| Project | IEEE 802.16 Broadband Wireless Access Working Group < http://ieee802.org/16 > | |
| Title | Pilot and Cluster Allocation in Downlink PUSC – Reply to Comment #436, #494, #501, #503 | |
| Purpose | Proposal for modifications to the structure of the PUSC scheme in OFDMA mode. | |

Figure 3 – Downlink PUSC, 2-Antenna STC

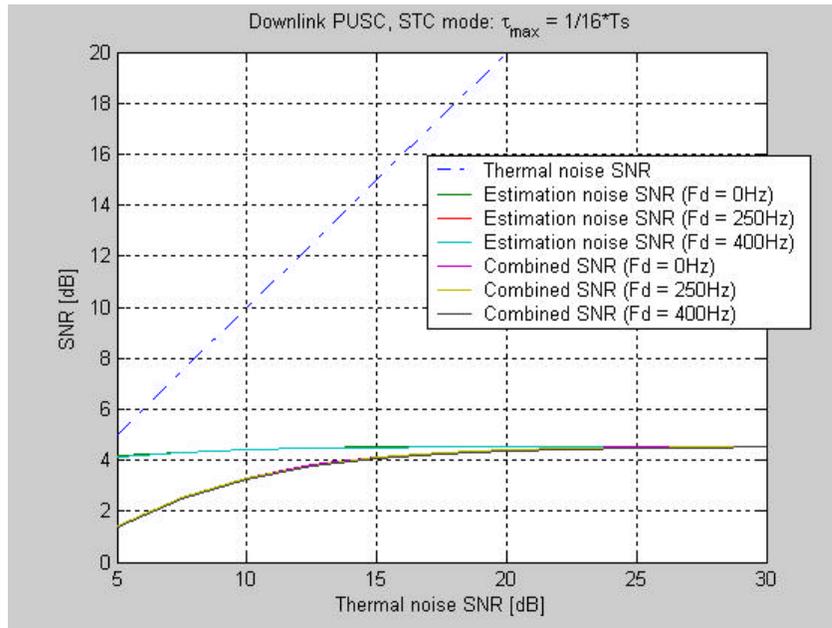
In DL PUSC, clusters are not contiguous in the frequency axis; therefore we are limited to estimating the channel from the pilots that reside inside the cluster (perhaps over several symbol durations). In the 2-antenna STC mode, pilots are only transmitted in the odd symbols. 2 pilots, spaced 12 subcarriers apart, are transmitted by each antenna. When 4 antennas are used, data subcarriers are punctured and pilots take their place – As a consequence, identical channel estimation loss is expected.

This scheme completely fails in high multi-path conditions, as is shown in Figure 3 for $t_{\max} = \frac{1}{16} \cdot T_{\text{sym}}$.

Figure 8 - Comparison between current and proposed DL PUSC structures, 2-Antenna STC.

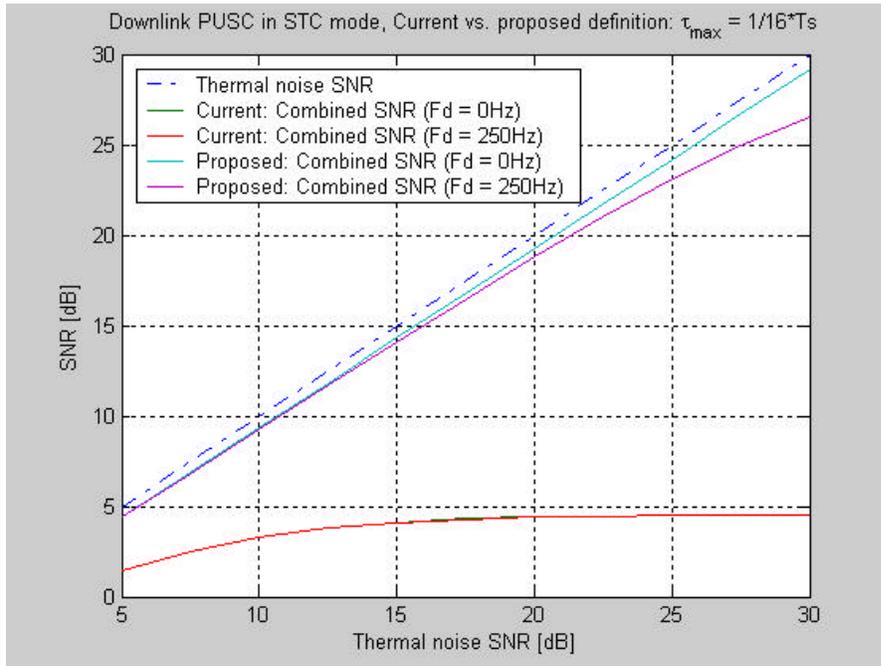
The proposed cluster structure does indeed solve the severe estimation problem for the PUSC STC modes. This is shown in Figure 8 to Figure 10 below.

Figure 246 - 2-Antenna STC structure for DL PUSC

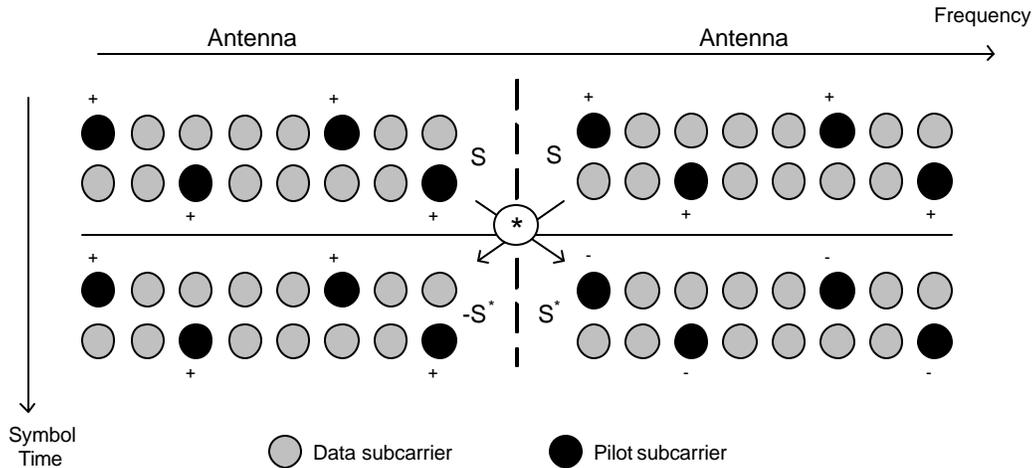
[Replace Figure 246 with the following figure]

The clusters composing the subchannels used by the STC mode shall be allocated and subcarriers numbered as defined in 8.4.6.1.2.1. Pilots are transmitted simultaneously from both antennas using the same pilot locations as defined in Figure 234. In this scheme, transmission on regular subchannels and STC subchannels is possible and is determined by the MAC layer (the allocation is performed by allocating major groups of subchannels for regular or STC transmission). The transmission of the data shall be performed in pairs of symbols as illustrated in Figure 246. Each symbol-pair shall be transmitted twice from each antenna. The pilots transmitted from antenna #1 during every 2nd symbol-pair shall have negative polarity (prior to pilot modulation). All other pilots shall have positive polarity (prior to pilot modulation).

Figure 251 - Two consecutive DL PUSC clusters in 4 Antenna STC mode.

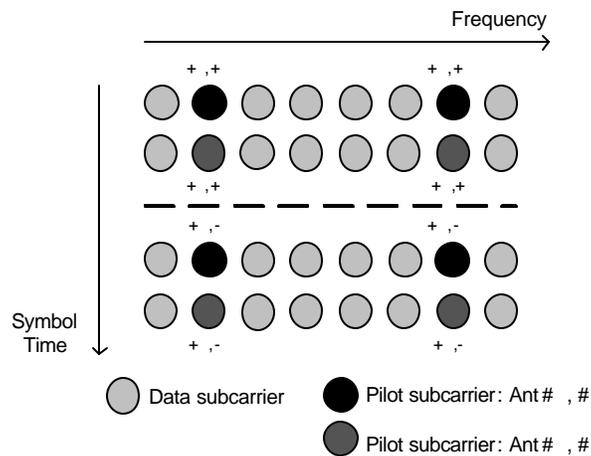
[Replace Figure 251 with the following figure]

For this configuration the pilot locations in the basic cluster structure are changed as indicated in Figure YYY to accommodate transmission from 4 antennas. Antenna #0 and antenna #1 use the pilots located in the first and third symbols of each two consecutive clusters, while antenna #2 and antenna #3 use the pilots located in the second and fourth symbols of each two consecutive clusters. Antenna #1 and Antenna #3 transmit pilots with negative polarity at the third and fourth symbols, respectively. This is depicted in Figure 251.
